**ADDENDUM  
NO. 3**

**September 30, 2025**

**VALE FACILITY ADDITION/RENOVATIONS AND  
MAINTENANCE/IT FACILITY PROJECTS**

**Addendum Three (AD.03)** to the drawings and specifications prepared by Gibraltar Design for **Valparaiso Vale Facility Addition/Renovations and Maintenance/It Facility and Related Work** for Valparaiso Community Schools, Valparaiso, Indiana.

SHEET  
**A-411**

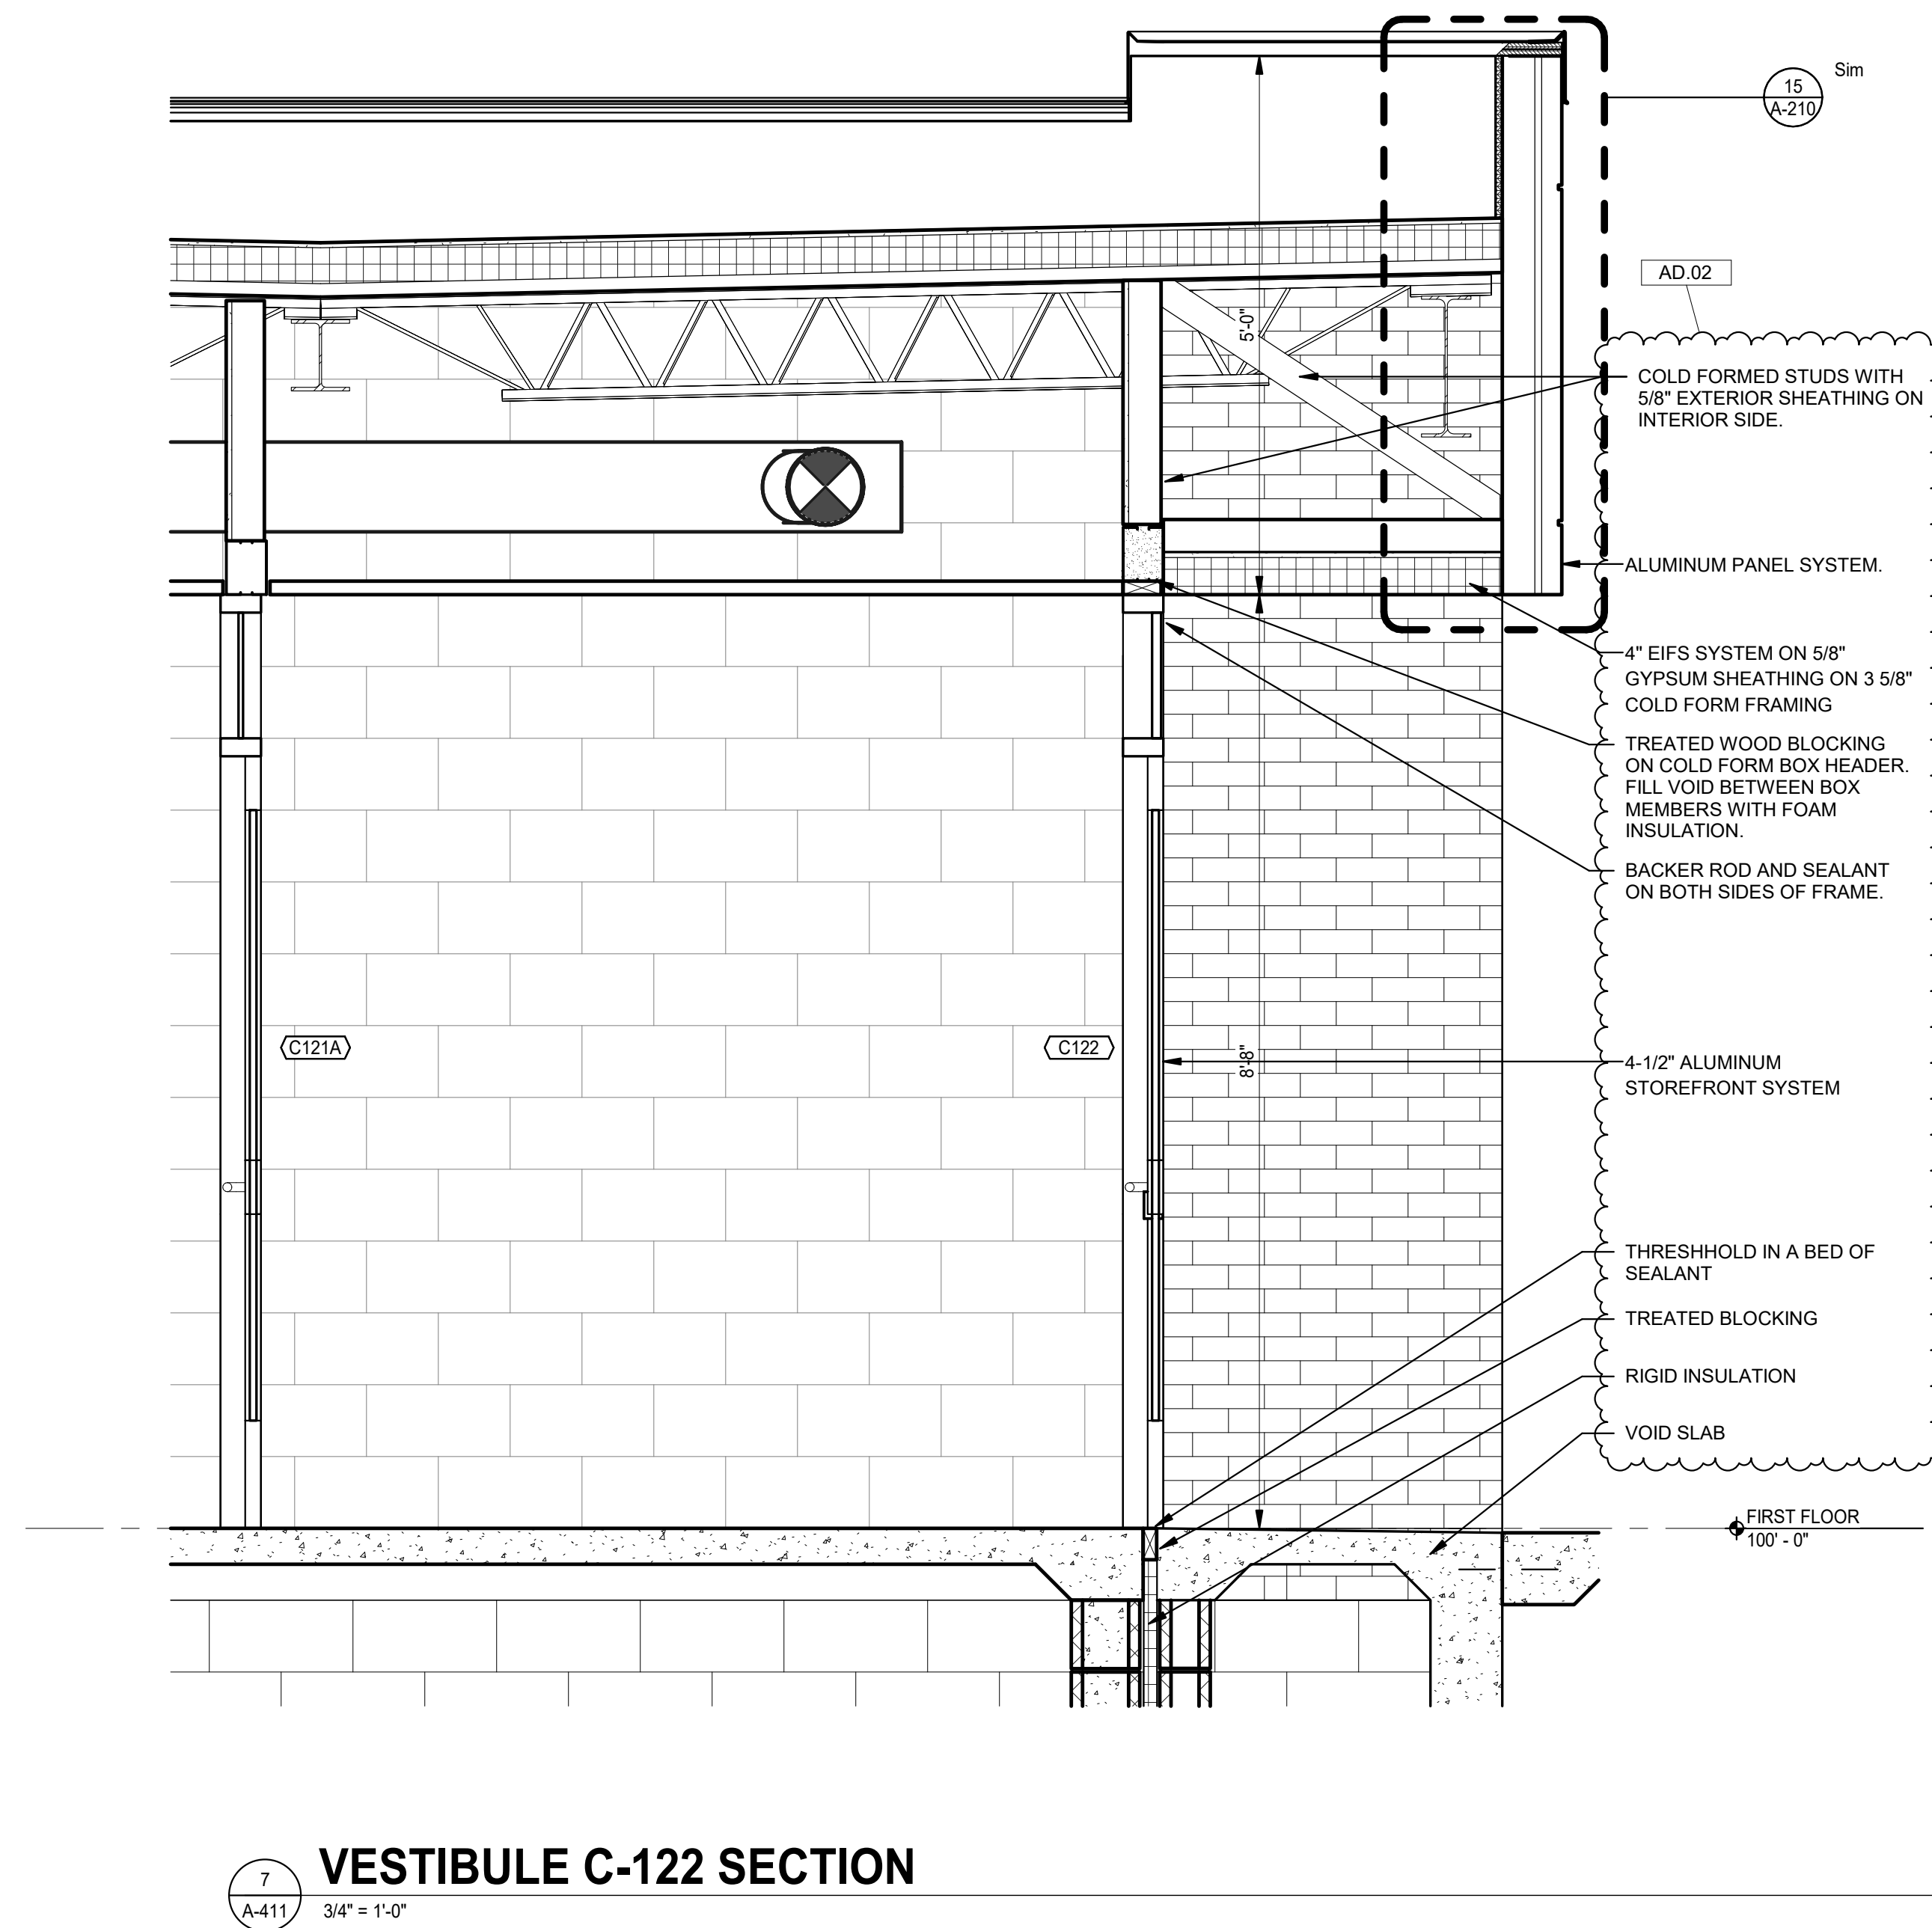
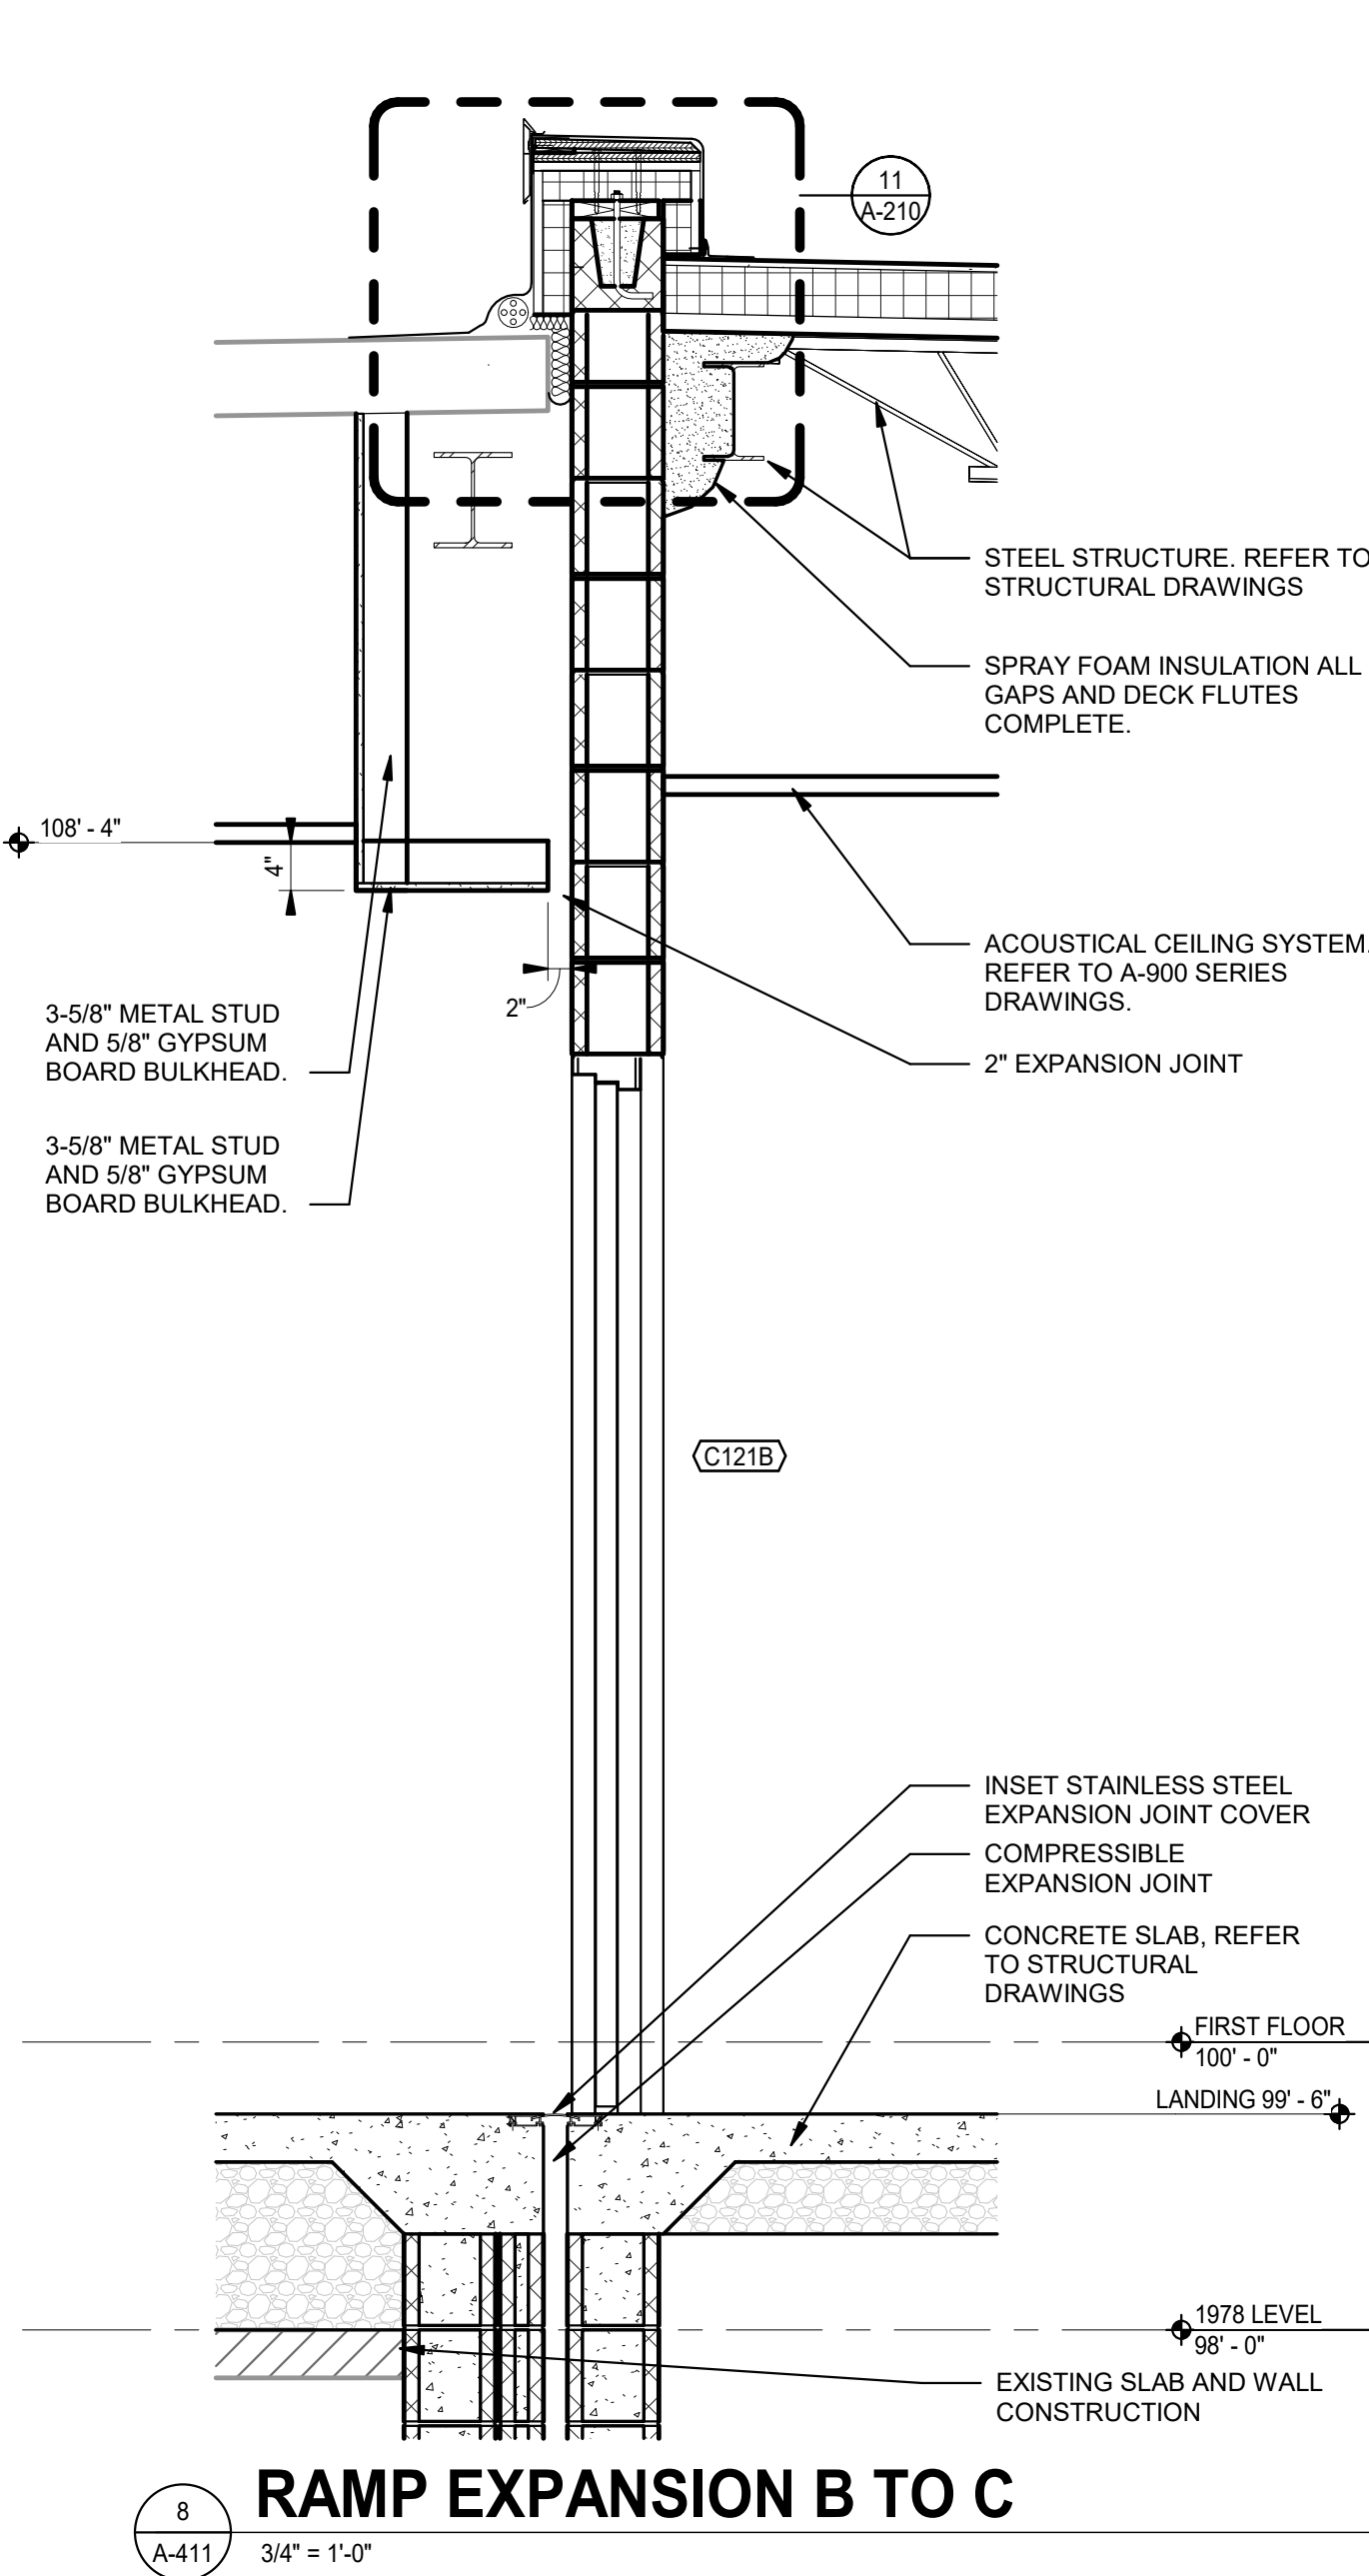
- A. Refer to revised, full-size drawing, included in this Addendum, for revisions.
  - 1. Added / Clarified expansion joints at slab to wall conditions.
  - 2. Clouded bottom of new exterior walls to refer to detail 1/A-410.
